THE CITY OF SAN DIEGO

NOTICE OF PUBLIC MEETING

C.	Project	PTS 460884 – Costebelle Residence
	Location	2702 Costebelle Drive APN: 346-610-1000
	Description	<p>Site Development Permit to remodel and add a 7,195 sf second story addition and 3,059 sf below grade basement to an existing 2,339 sf one story residence on a 0.45-acre site.</p> <p><i>Additional Project Details:</i> Applicant to provide during the meeting.</p>
	Applicant	Ryan Farhood
	Project Contact	Ryan Farhood, Farhood.ryan@gmail.com , (858) 205-4112
	City Contact	Edith Gutierrez, EGutierrez@sanidiego.gov , (619) 446-5147

EXISTING TOPOGRAPHY & DEMOLITION PLAN

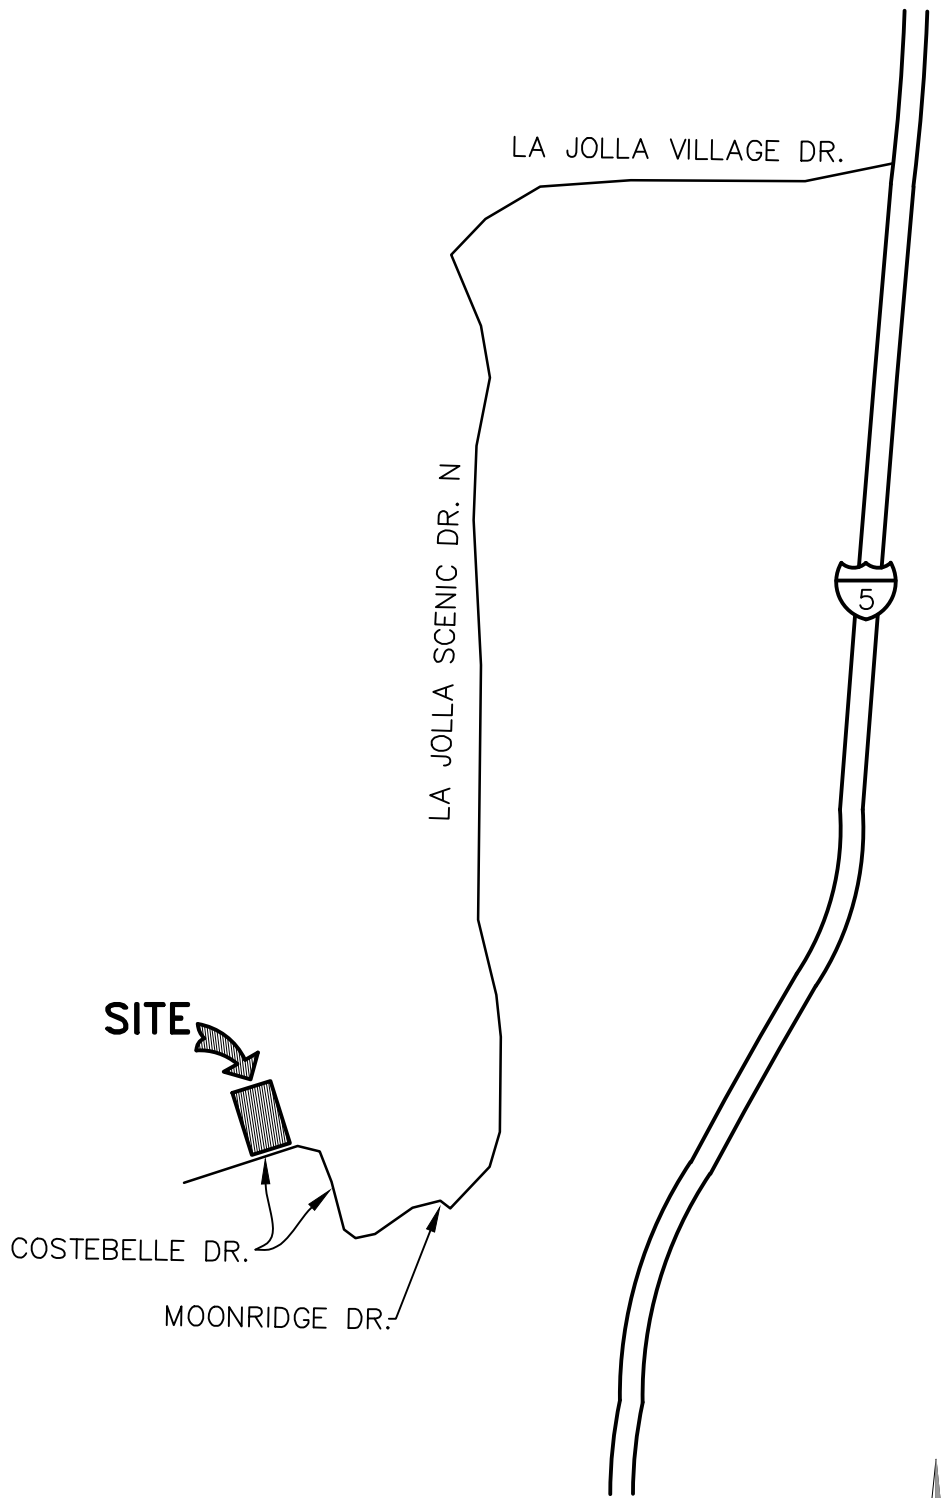
<input type="checkbox"/>	15	City's Storm Water Standards are available online at: http://www.sandiego.gov/stormwater/pdf/citysdstormwaterstandardsmanualdraft2015.pdf (New Issue)
<input type="checkbox"/>	16	Revise the Grading Plan, sheet C1.1. Show and call out how all storm water run-off from the proposed development is directed to proposed landscape Low-Impact Development BMPs. (New Issue)

WATER POLLUTION CONTROL PLAN

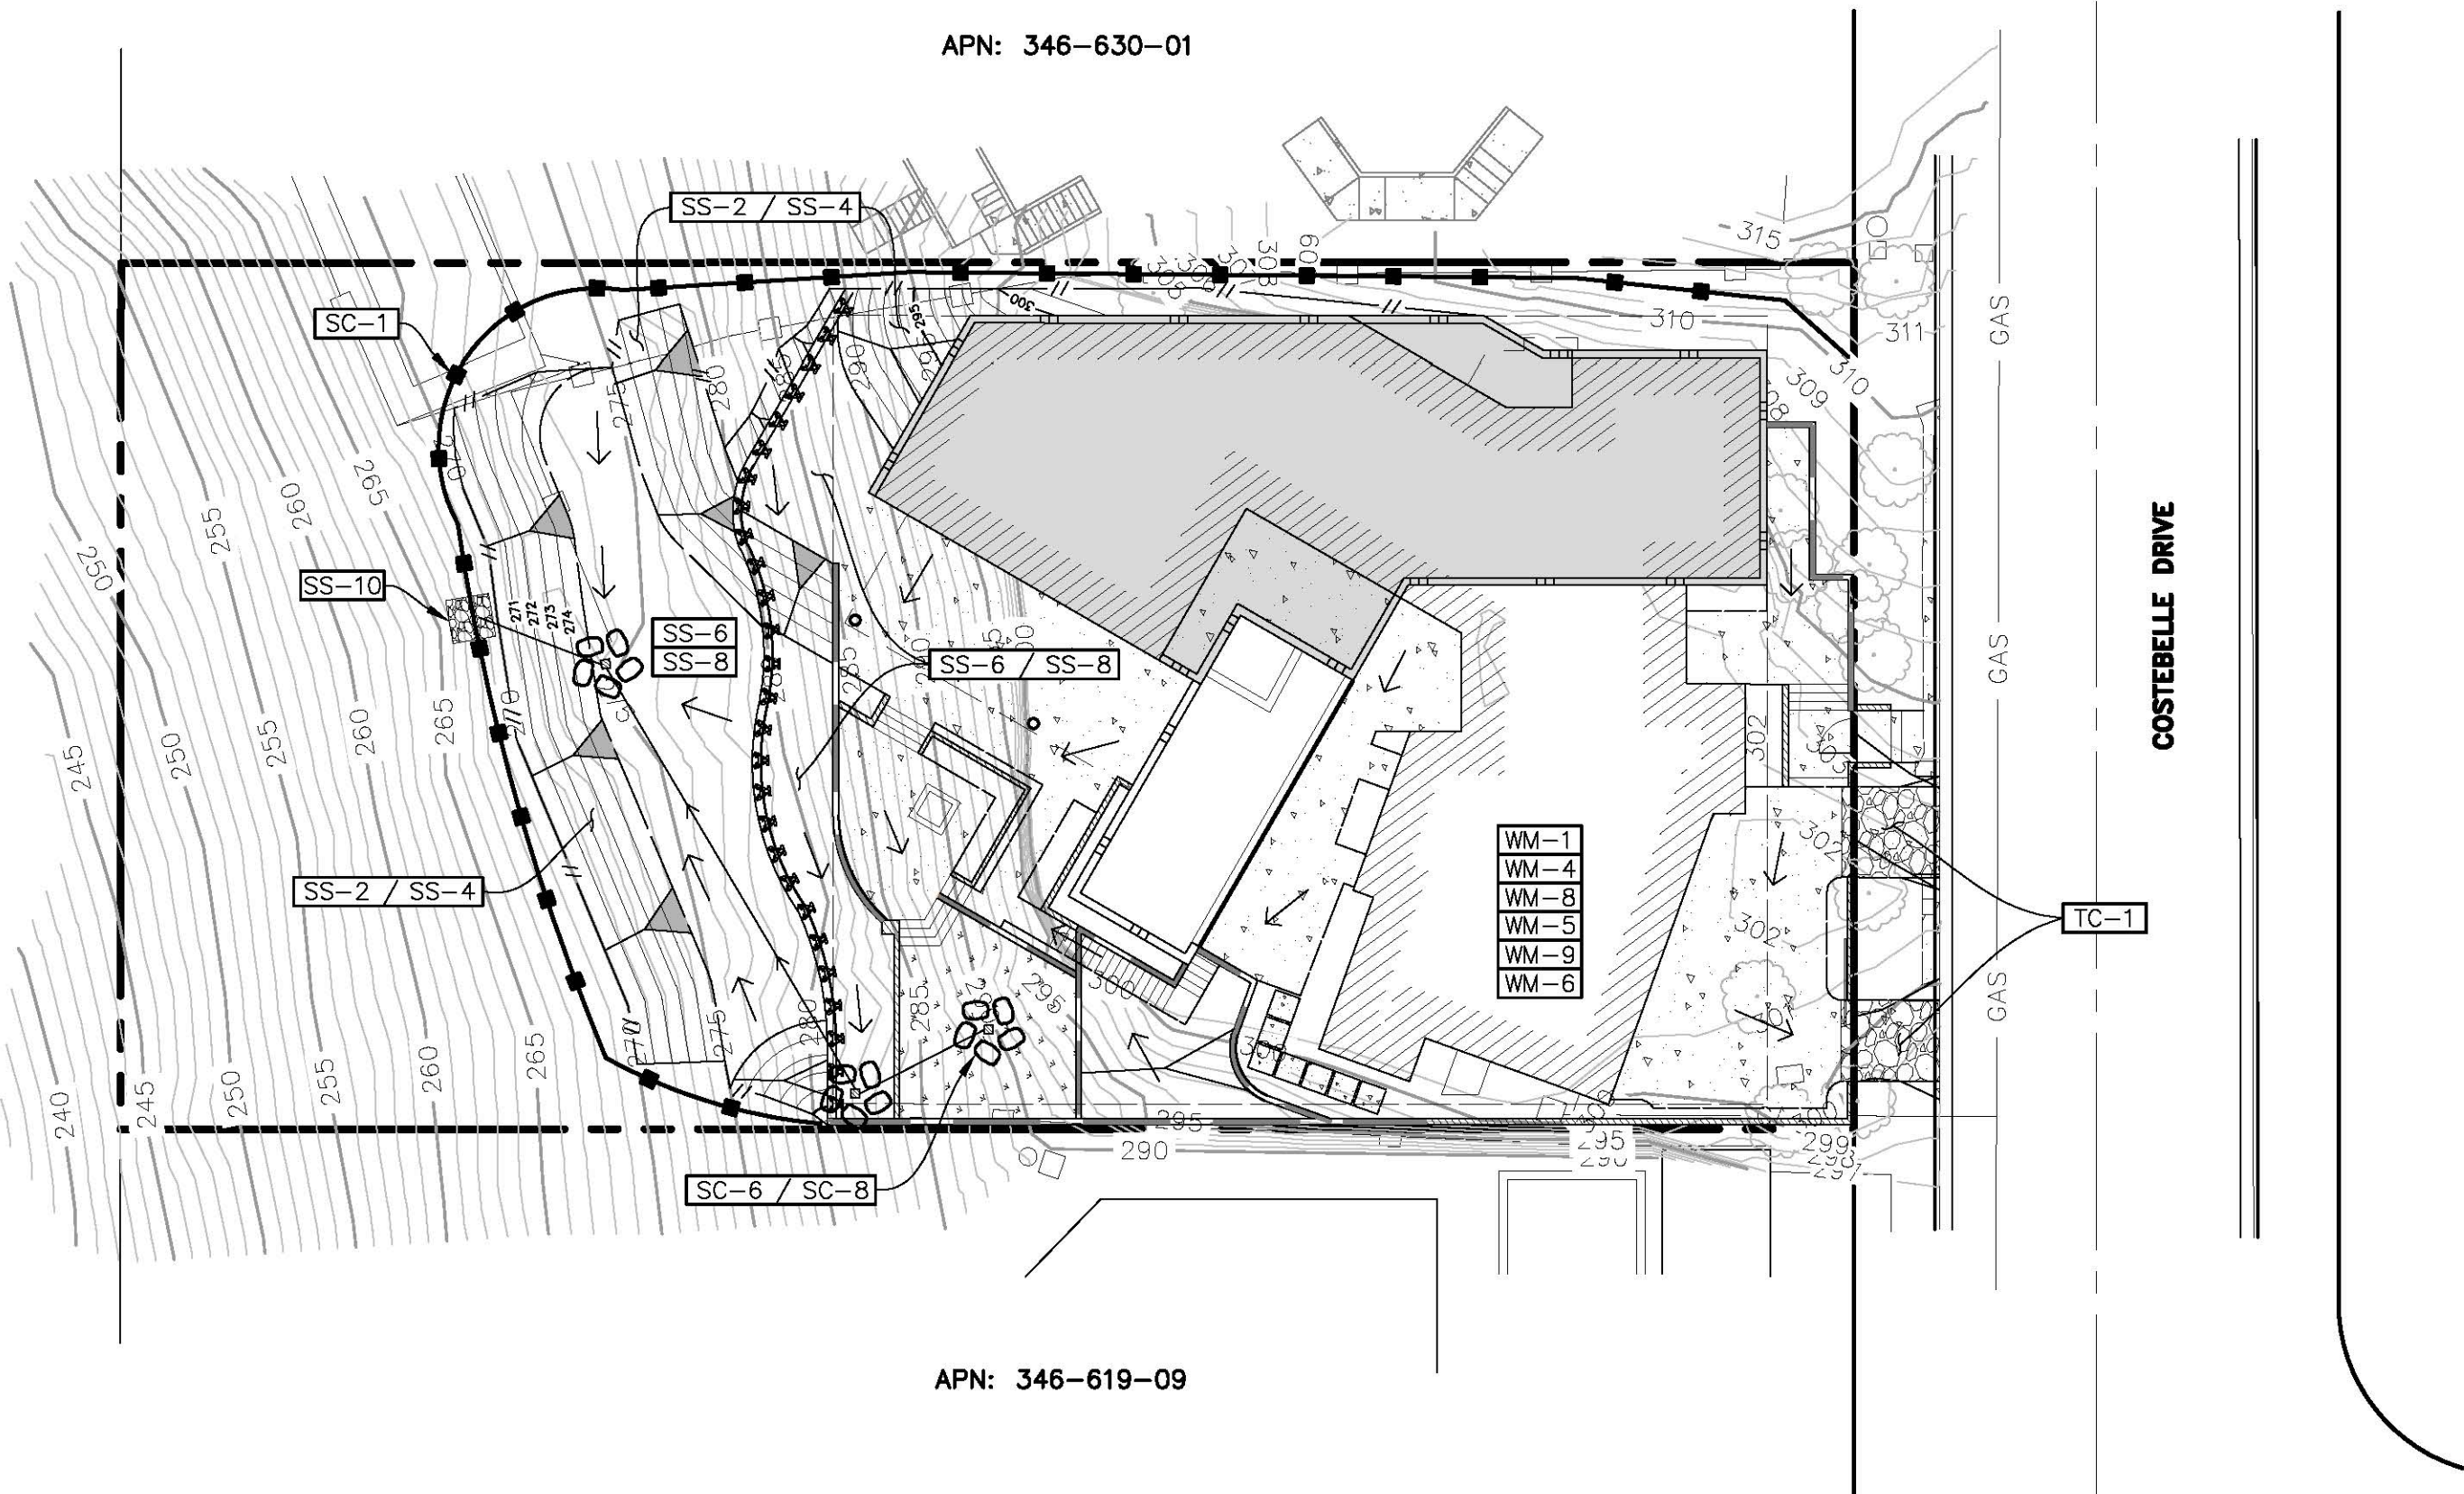
<input type="checkbox"/>	24	Revise the Site Plan, sheet A1.1. Add a note that states: Prior to the issuance of any construction permit the Owner/Permittee shall submit a Water Pollution Control Plan (WPCP). The WPCP shall be prepared in accordance with the guidelines in Part 2 Construction BMP Standards Chapter 4 of the City's Storm Water Standards. (New Issue)
<input type="checkbox"/>	25	Development Permit Conditions will be determined on the next submittal when all requested information is provided. (New Issue)
<input type="checkbox"/>	26	Additional comments may be recommended pending further review of any redesign of this project. These comments are not exclusive. Should you have any questions or comments, please call Khanh Huynh at 619 446-5299. (New Issue)
